# STAFF CASE REPORT TO PLANNING COMMISSION

<b>Subdivision Case Number:</b>	<b>2015-040</b>	<b>PC Meeting Date:</b> 09-14-15
<b>Subdivision Name:</b>	<b>Haisten on McCallie                  Lots 1 thru 3                  Urban Infill Lot Compatibility                  Option</b>	
<b>Applicant Request:</b>	Urban Infill Lot Compatibility Option	
<b>Property Location:</b>	1105 East 8 <sup>th</sup> Street	
<b>Property Owner:</b>	Haisten Family Partners	
<b>Applicant:</b>	David Mathews Surveying	
<b>Total Acreage:</b>	0.27 Acres	
<b>Proposed Density:</b>	11.1 dwelling units per acre	
<b>Tax Map Number:</b>	146H-K-027	
<b>Zoning:</b>	R-3 Residential Zone	
<b>Staff Recommendation:</b>	<b>APPROVE, Urban Infill Lot Compatibility Option</b>

FINAL PLAT

HAISTEN ON MCCALLIE

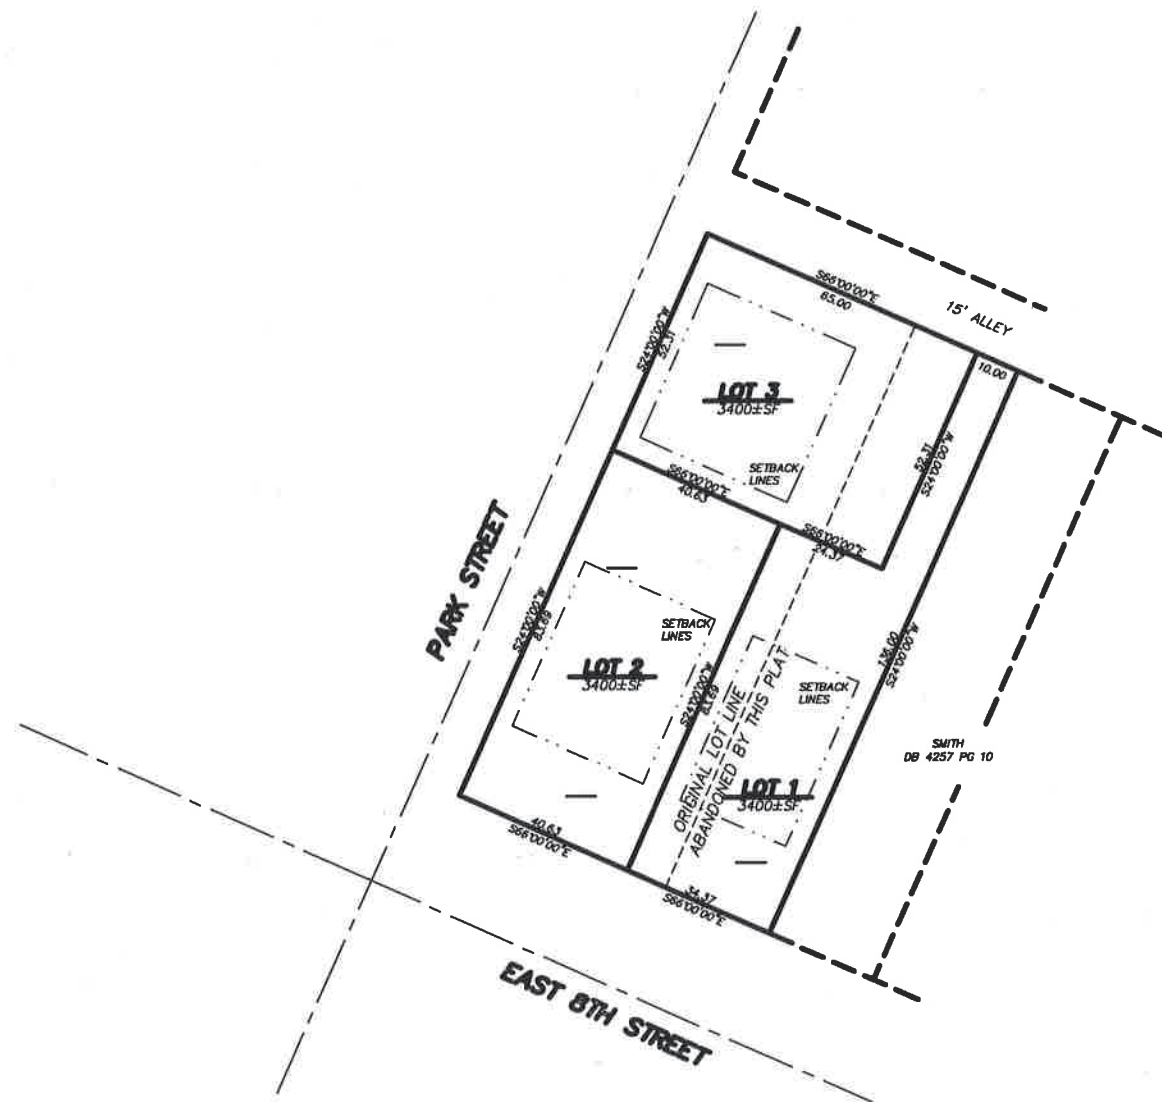
The following are additional comments and notes provided by RPA staff. This area was originally platted in 1888 by the recording of PB 2 Page 31. However, these lots were further divided around the early to mid 1900's by the recording of deeds. These lots are considered to be lots of record/deed lots since they were legally recorded prior to June 21, 1961.

The average frontage of the surrounding lots is multiplied by 90% to obtain the minimum lot frontage required for compatibility. The average lot frontage along East 8<sup>th</sup> Street is 31.13'; therefore, the minimum lot frontage required for the Urban Infill Lot Compatibility Option is 23.25' (31.13' X 90%). Proposed lots 1 thru 3 comply with and exceed the minimum lot frontage requirements of the Urban Infill Lot Compatibility Option.

The average lot area of the surrounding lots is multiplied by 75% to obtain the minimum lot area required for compatibility. The average lot area along Rosewood Avenue is 3,769.7 square feet; therefore, the minimum lot area for the Urban Infill Lot Compatibility Option is 3,392 square feet (3,769.7 X 75%). Proposed lots 1 thru 3 comply with and exceed the minimum lot area requirement of the Urban Infill Lot Compatibility Option.

Approve the Urban Infill Lot Compatibility Option
